**REFERENCE: APPLICATION FOR CATEGORY 1, CLASS "A" LICENCE
CAPITAL PAVING INC., MONTROSE PIT
PARTS OF LOTS 71, 74 & 75 CONCESSION G.C.T
TOWNSHIP OF WOOLWICH, REGION OF WATERLOO**

**RE: Technical Response
Ministry of Natural Resources comment letter dated Oct. 15, 2008
Proposed Capital Paving Inc. Montrose Pit.**

**Reference: Capital Paving Inc., Montrose Pit
Part of Lots 71, 74 & 75, Concession G.C.T.
Township of Woolwich, Region of Waterloo
MNR Response Letter (October 15, 2008)
Stantec Consulting Ltd. Technical Response**

<p>Scale: as shown Date: February 2009</p>		<p>Revised North Creek Catchment</p>	
<p>Hydrogeologic Assessment</p>		<p>Capital Paving Inc. Proposed Montrose Pit Part of Lots 74 and 75, Concession GCT</p>	
<p>Groundwater Science Corp.</p>		<p>Township of Woolwich, Region of Waterloo</p>

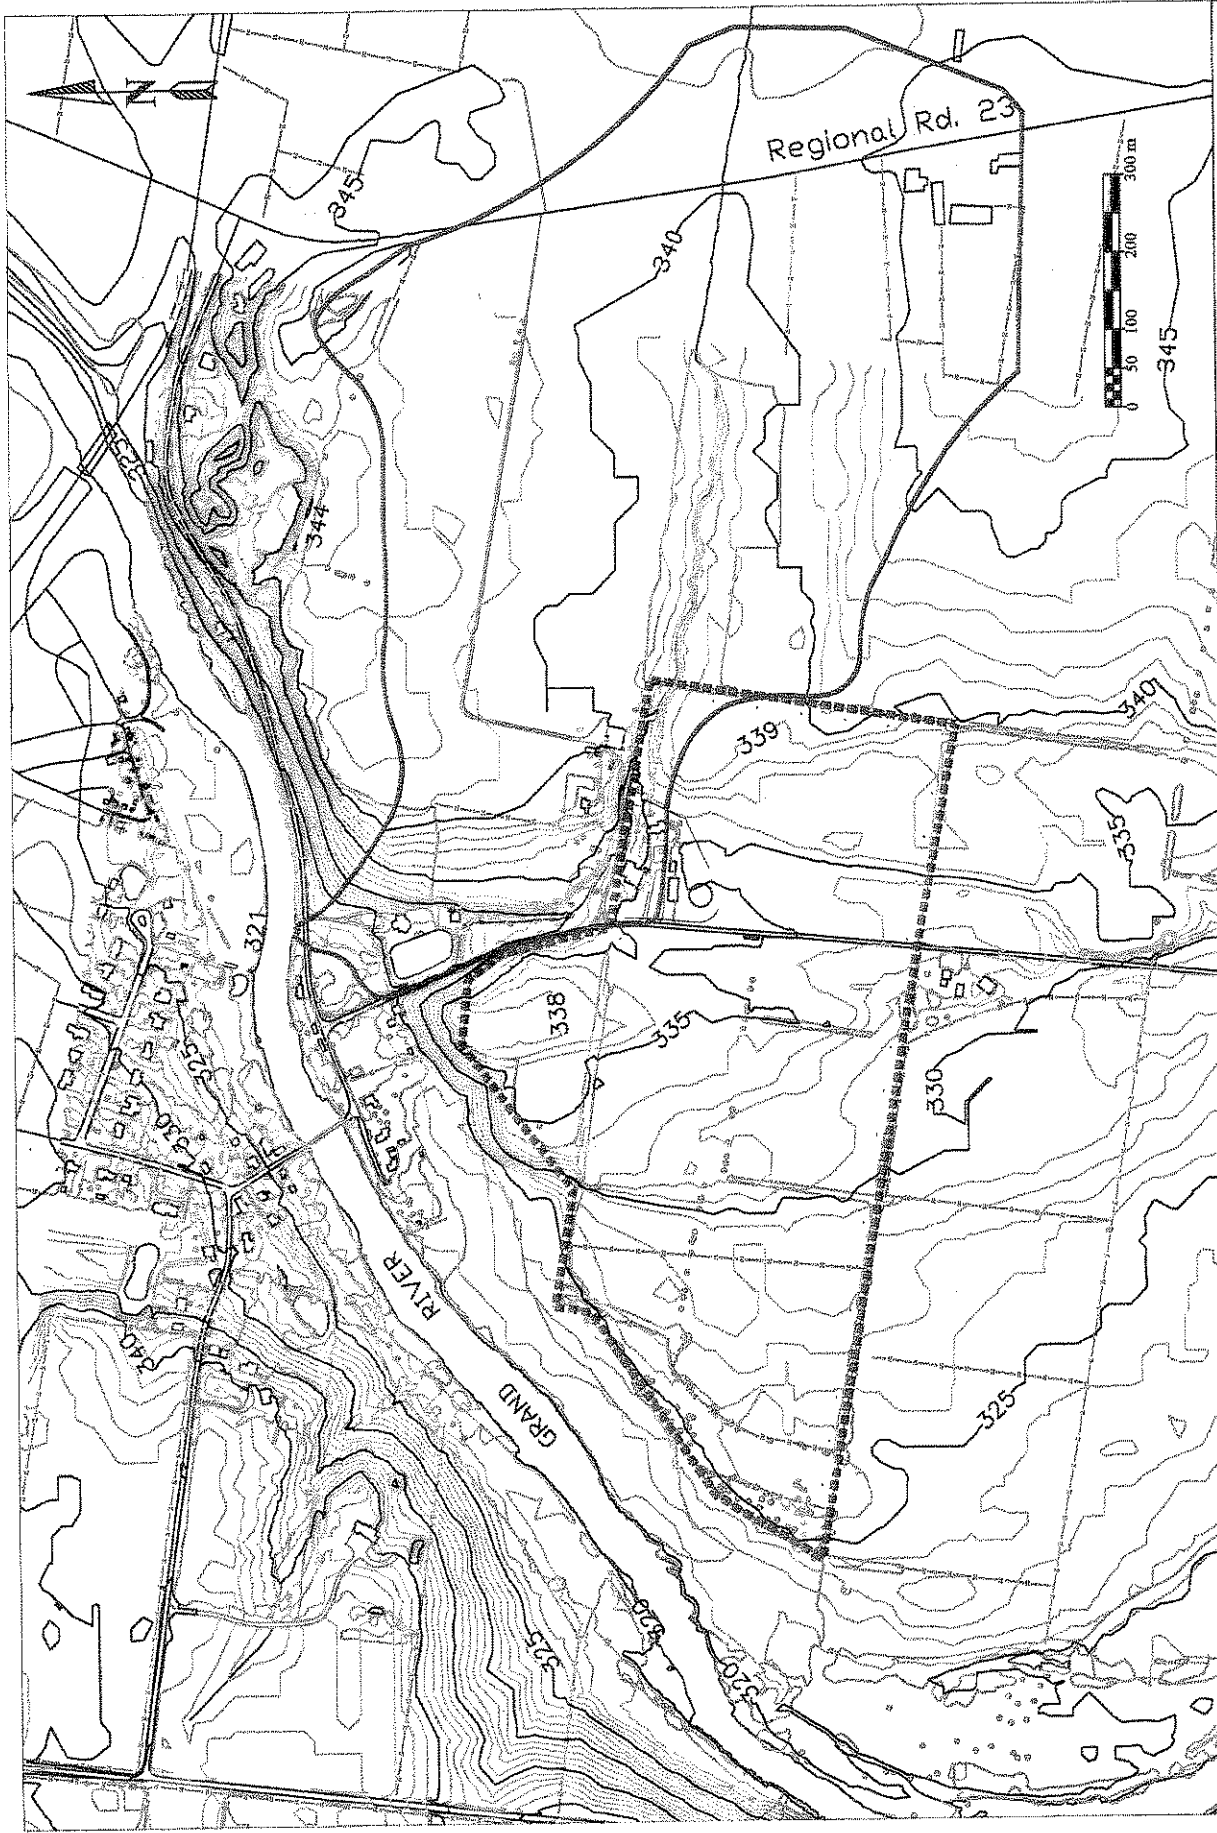
MNR requested that the surface flow patterns be reviewed for the northern creek catchment, specifically the use of Regional Road 23 as a local divide. The flow patterns have been reviewed through field inspection and discussions with the landowners. The landowners report that flow through the culvert at Regional Road 23 is from east to west. This was confirmed during the January 28, 2009 site visit with MNR. The landowners also indicate that flow within this creek actually originates within the wetland located east of Regional Road 23. This expands the surface water catchment further east.

In addition, the catchment boundaries near the site and within extraction areas were reviewed. It is reported that no culvert crosses Letson Road north of the site. This implies that any surface water runoff from the site in this area would flow within the roadside ditch along the west side of the road and toward the small "park" at the corner of Rivers Edge Road and Letson Road. Therefore this surface water flow would therefore not contribute directly to the northern creek. In this area the catchment divide is now estimated to be the centerline of Letson Road.

The topography at the northeast corner of the site was also inspected, and based on field observations the catchment boundary was revised slightly.

The revised catchment area delineation, based on the above observations, is attached to this letter. As shown, the total catchment area is now estimated to be 70.7 ha (approximately 5.7 ha larger than previously estimated), and the potentially disturbed area is estimated to be 0.6 ha (2.1 ha smaller than previously estimated). Therefore the potentially disturbed area represents approximately 0.9% of the total northern creek catchment area.

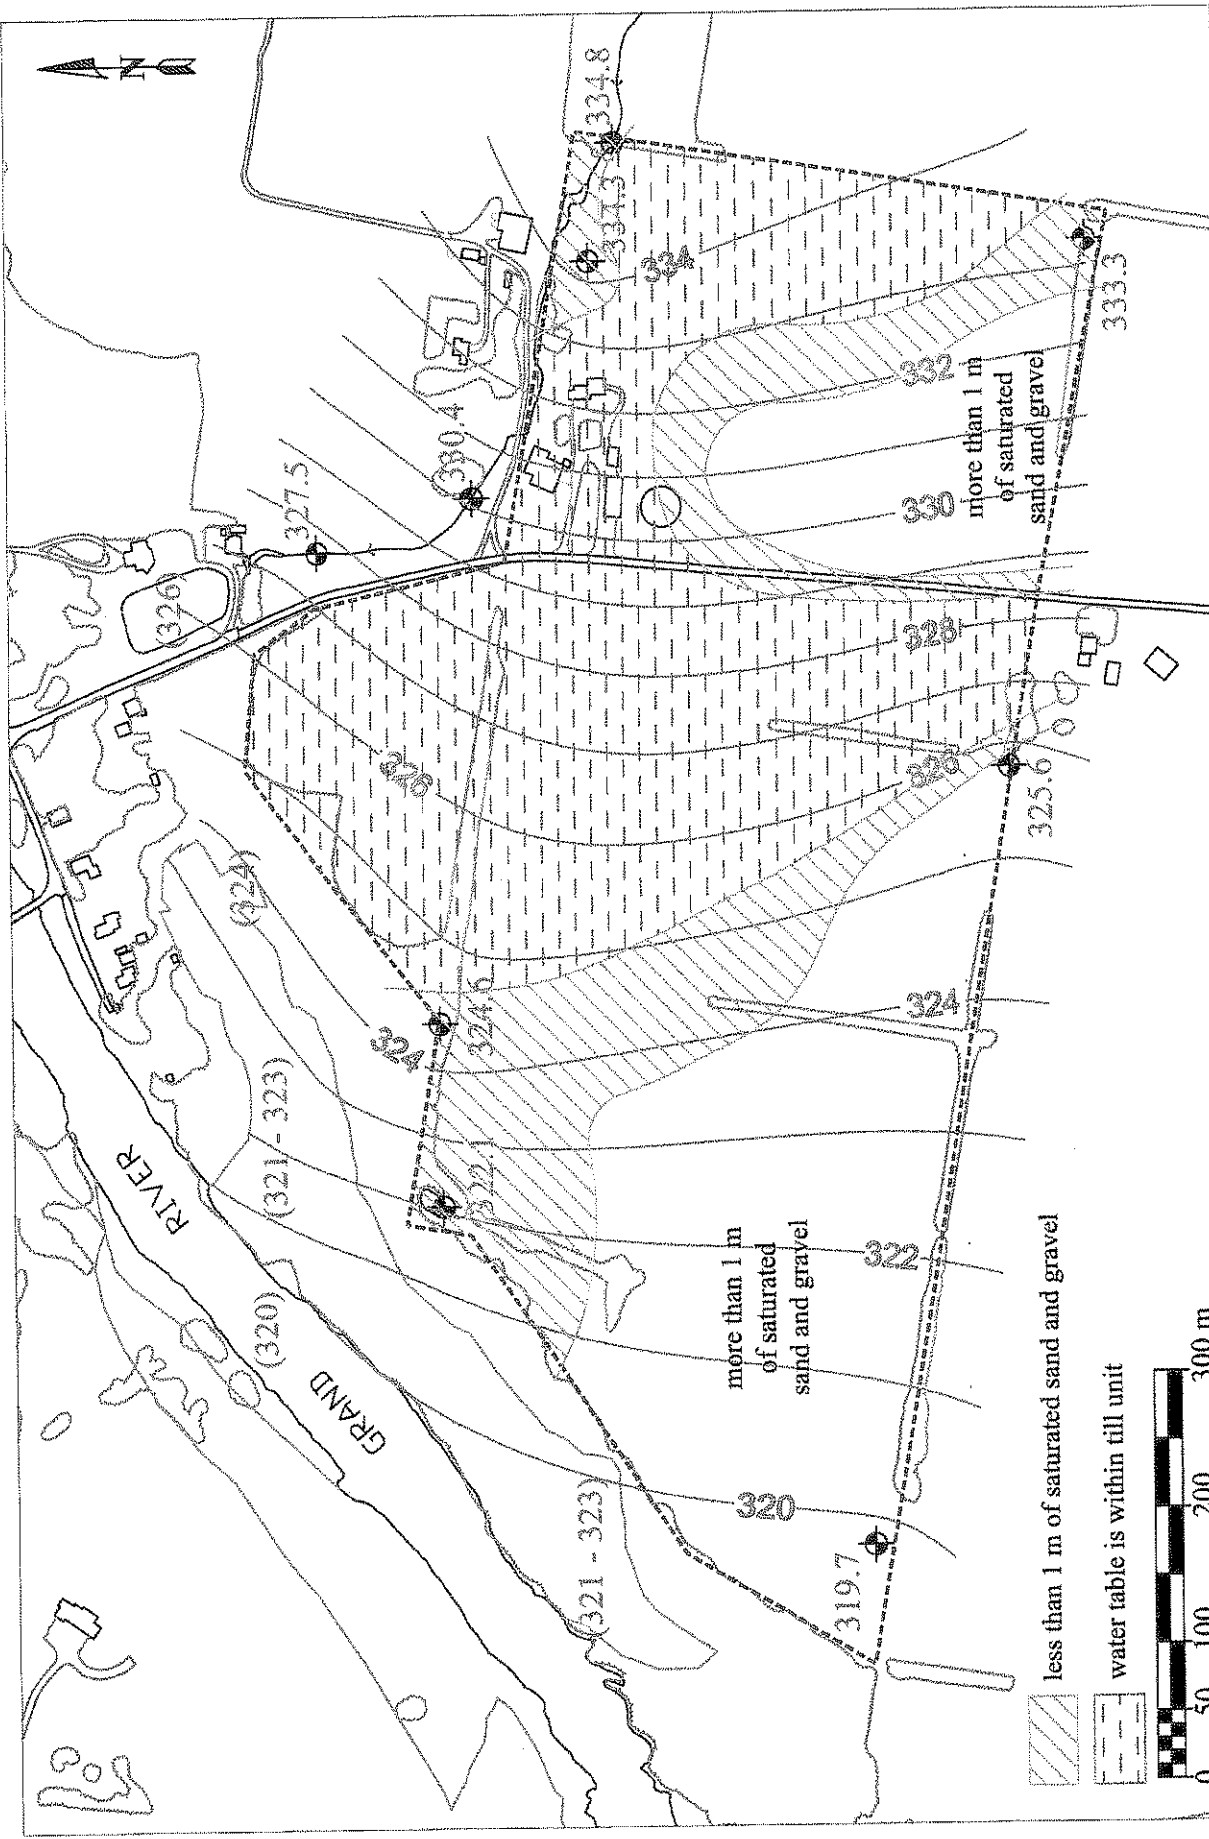
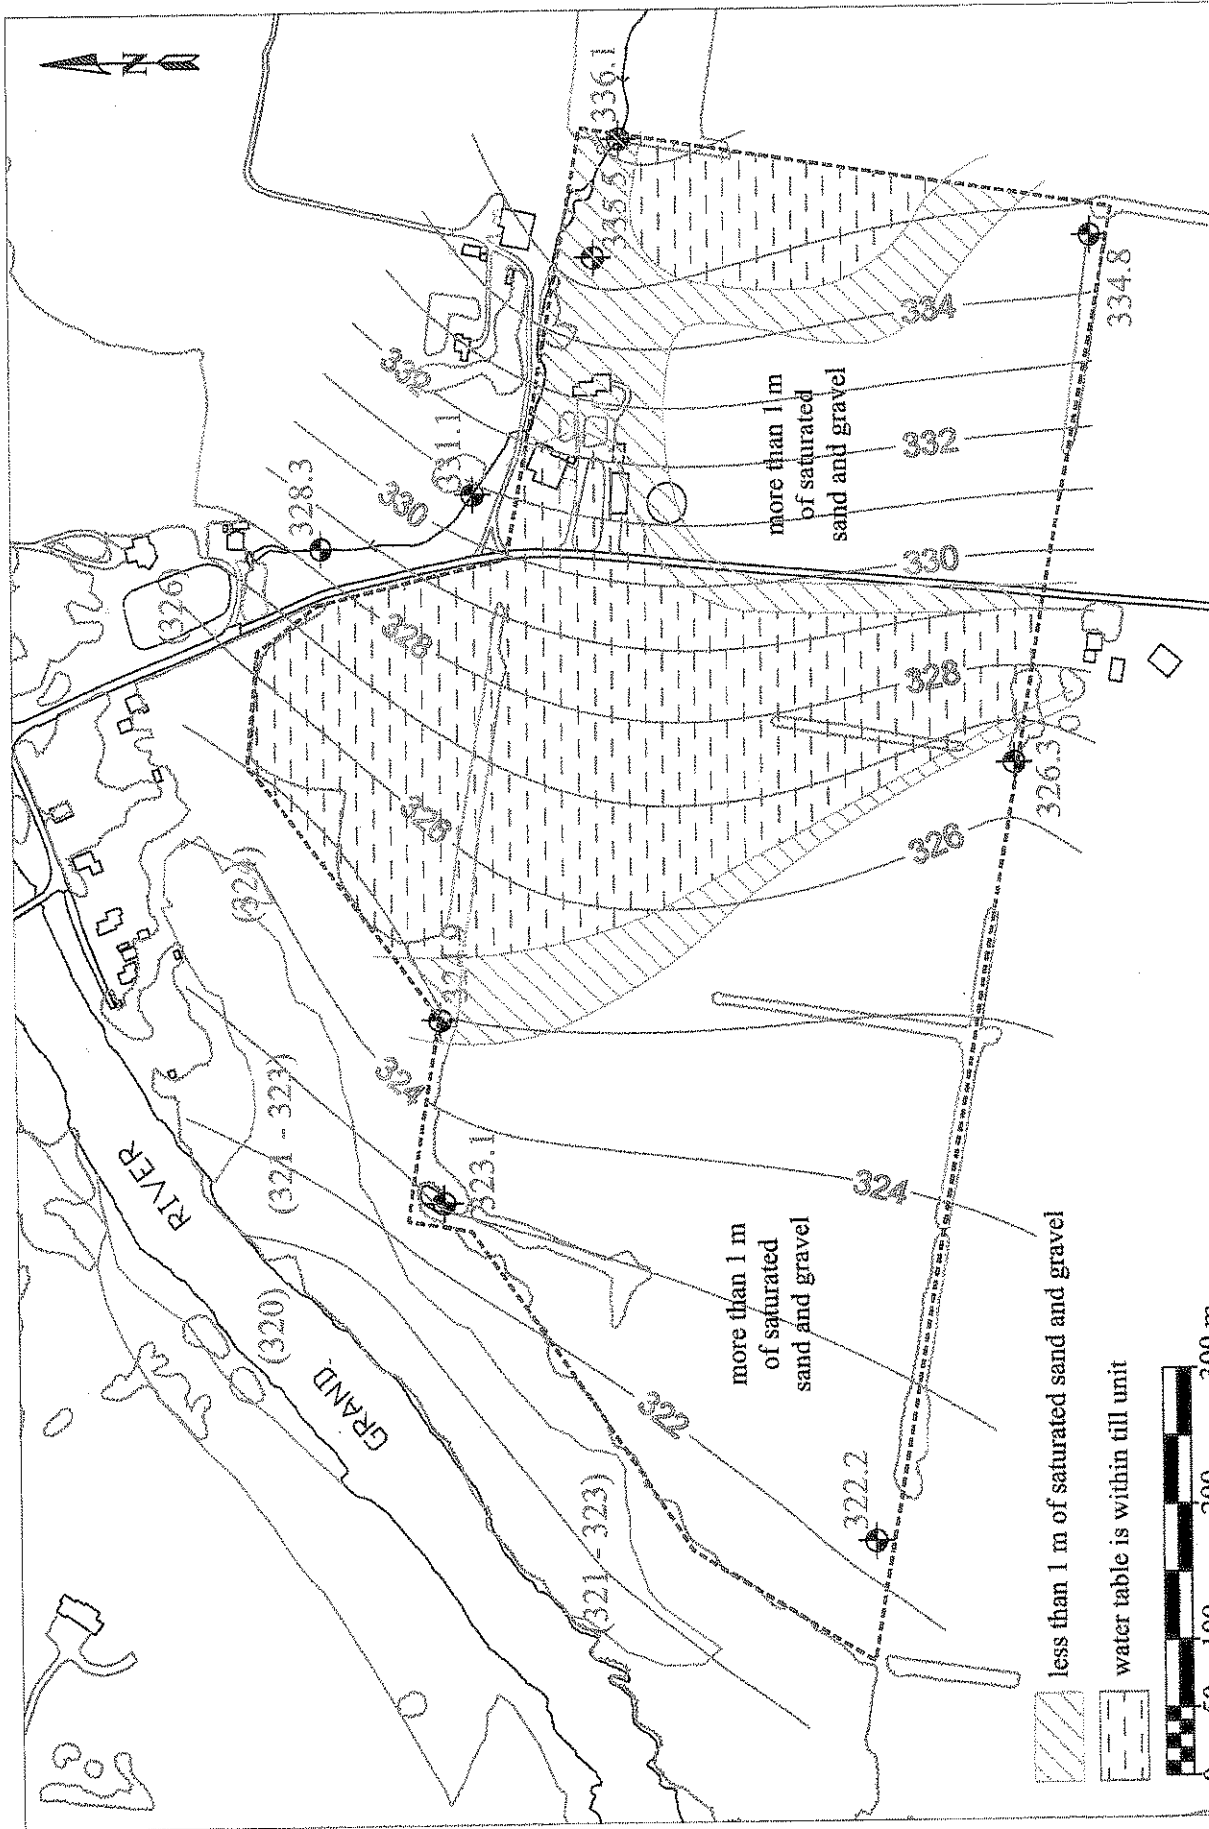
Clarification regarding extraction of till and impact to groundwater flow to north creek. Verification of the north creek catchment area.

Based on the monitoring results we have compiled water table elevation maps showing both low water table conditions (Fall 2007) and high water table conditions (Spring 2008). The maps are attached to this memo. Note that for the purposes of the Site Plan the established water table is based on the December 2006 groundwater elevations, which were the highest on record at the time of the application report. The groundwater elevations in December 2006 were similar to those measured in Spring 2008 (difference of between 0.01 and 0.17 m within the above water table extraction zones).

Comparing the low and high water table elevations and the elevation of the till unit (as shown on Figure 4 in the March 2008 report) we have delineated the areas on-site where the water table is within the till unit and where the water table is within the sand and gravel unit. The areas are shown on the water table maps. The comparison shows that over the eastern portion of the site groundwater flow is largely within, and controlled by, the till unit. Within this area the water table elevation and slope is higher. Groundwater flow will be relatively slow, controlled by the fine-grained nature of the till unit.

West of this area, where the water table is within the sand and gravel unit, the water table slope is lower and groundwater moves more "freely" toward the river. The figures also illustrate that during dry periods (e.g. in the summer and fall) the sand and gravel (water table) unit has a saturated thickness of less than 1 m over a significant portion of the site. This indicates the limited nature of the water table unit at the site and the overall low flow volume toward the river and associated wetland. During dry periods the water table near the southwest corner of the site is also significantly lower than the wetland along the Grand River. The water table elevation in this area likely creates very dry conditions at surface. The wetland occurs along the river north of this area, where both the till unit and the water table is at a higher elevation.

Scale: as shown Date: January 2009		Local Cross-Section Locations	
		Capital Paving Inc. Proposed Montrose Pit Part of Lots 74 and 75, Concession GCT Township of Woolwich, Region of Waterloo	
Hydrogeologic Assessment		<i>Groundwater Science Corp.</i>

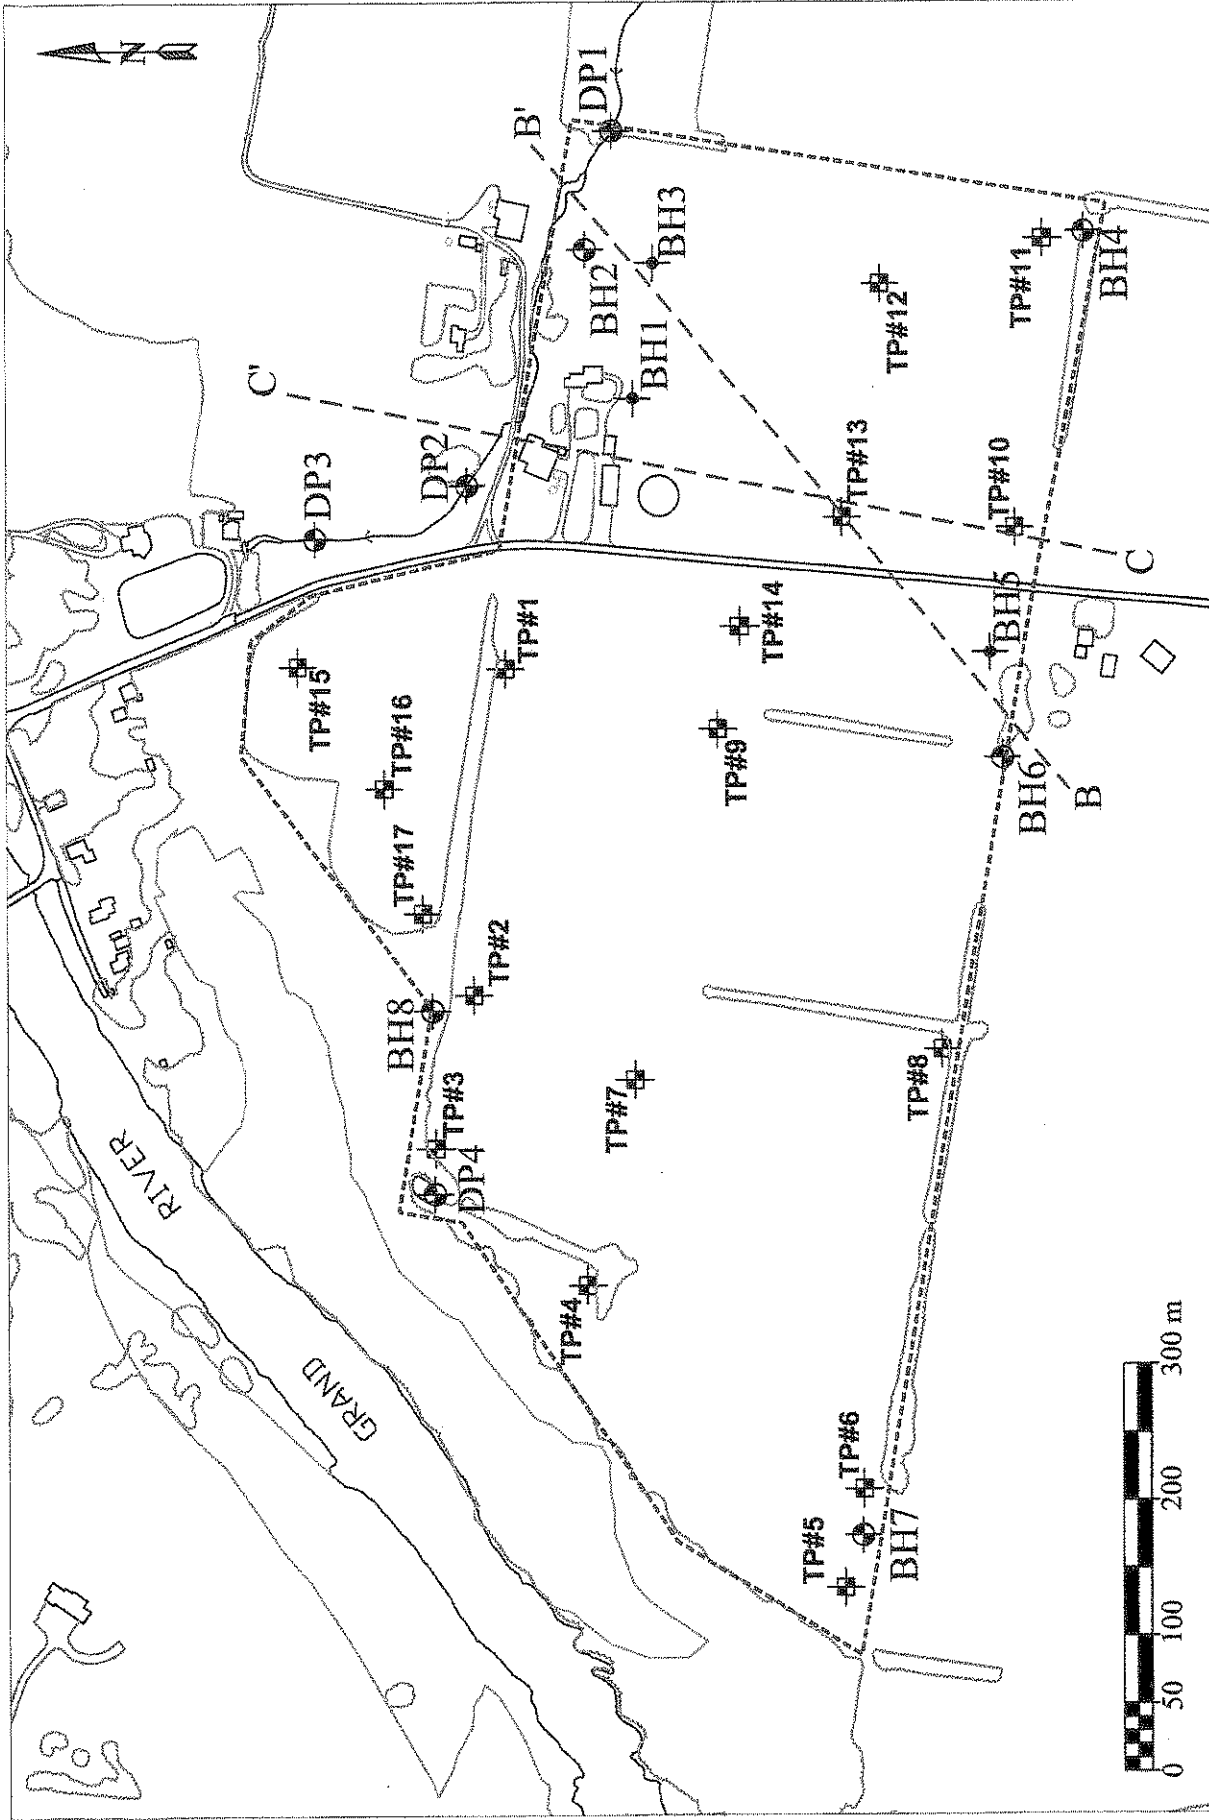
Clarification of groundwater-surface water interaction along northern creek.

In order to illustrate conditions near the northern creek we have constructed two local schematic cross-sections (B - B' and C - C'), as shown on the attached figure. The cross-sections are also included with this memo.

The cross-sections show the relative positions of the till unit and high and low water table elevations with respect to the extraction area and the creek channel between DP1 and DP2. Note that the till sequence includes both the Port Stanley (sandy to silty) Till near the surface and the Maryhill (clay) till at depth. Near the creek the till surface rises up to, or above, the creek channel bottom. The creek channel at DP2, and downstream to the north, is developed within the till unit. The till unit effectively captures local recharge and directs local flow along the channel and limits the amount of water that moves from the creek to the sand and gravel unit on-site.
